Collaboration on Energy and
Environmental Markets

Response to Frequency control rule changes directions paper

04 February 2021

Figure 1: Active power output and dispatch levels and trajectories determined by ASEFS for a solar plant on 4/7/2020.

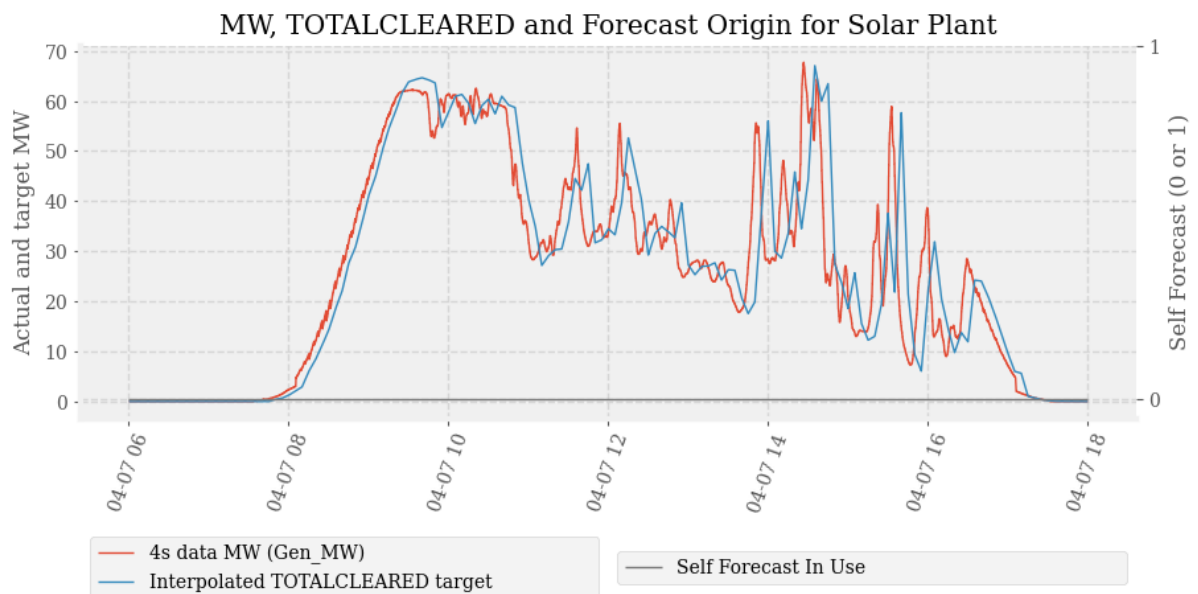
However, we cannot support this approach in practice as variable renewable energy (i.e. semi-scheduled plant) may share a greater burden of the costs than they arguably should due to the regulation FCAS Causer Pays calculation process. The calculation of contribution factors for scheduled and semi-scheduled generation for a dispatch interval involves calculating the deviation of a unit from a linear trajectory between the previous dispatch target and the next dispatch target (i.e. the TOTALCLEARED value for the previous dispatch interval and the current dispatch interval) every 4 seconds⁶². For semi-scheduled generation, the TOTALCLEARED value is based on AWEFS for wind farms, ASEFS for solar farms or participant self-forecasting. In the case of AWEFS/ASEFS, persistence forecasts are often used. For a given dispatch interval, these persistence forecasts use active power output SCADA data from up to two minutes before the end of the previous dispatch interval to produce a forecast for the TOTALCLEARED value for that interval (see Figure 1 and Figure 2)⁶³. Our analysis of SCADA and dispatch data for a week in July 2020 suggests that this translates to a persistence forecast that is lagged by approximately seven minutes, and that such forecasts appear to be in widespread use for variable renewable energy⁶⁴. As such, Causer Pays appears to be assessing semi-scheduled plant against a trajectory that is approximately seven minutes old. We think that the use of a lagged trajectory in assessing dispatch compliance is inappropriate.

Semi-scheduled plants are consistently receiving negative contribution factors⁶⁵. While it is unclear whether this outcome is wholly an artefact of the calculation methodology or potentially the result

of their active power deviations and consequent adverse impacts on system frequency control, the methodology in use for semi-scheduled generation does not seem to be fit for purpose. We cannot support this cost-allocation solution if Causer Pays (or a frequency response deviation pricing approach) uses this methodology to calculate contribution factors for semi-scheduled generation. UNSW CEEM has published research that suggests a potential solution – use the input data to predict INITIALMW (active power output at the beginning of the dispatch interval) and maintain this forecast for the entire interval⁶⁶. The linear trajectory could then be calculated between the INITIALMW values (see Figure 3). While preliminary analysis of this simple solution suggests that it reduces lag and therefore provides a better indication of compliance/deviation, we suggest this methodology be further considered by AEMO and the double-sided causer pays working group.
